STAFF REPORT
(One-Step Final Plat)

CASE NUMBER: SUB 2004-62 -- TYLER'S LANDING COMMERCIAL ADDITION

SUB 2004-62 -- One-Step Final Plat of TYLER'S LANDING COMMERCIAL ADDITION
June 17, 2004 - Page 4

VICINITY MAP

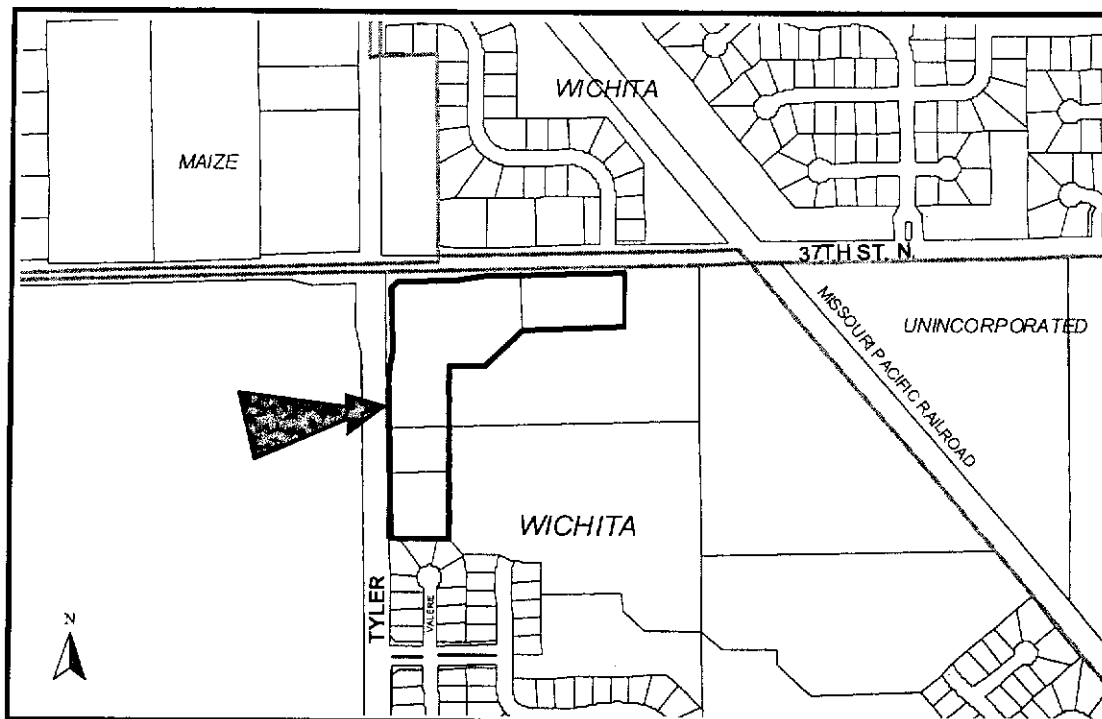
- G. The applicant shall participate in the paving petition for 37th St. North.
- H. The vicinity map needs to be corrected to denote 37th Street North.
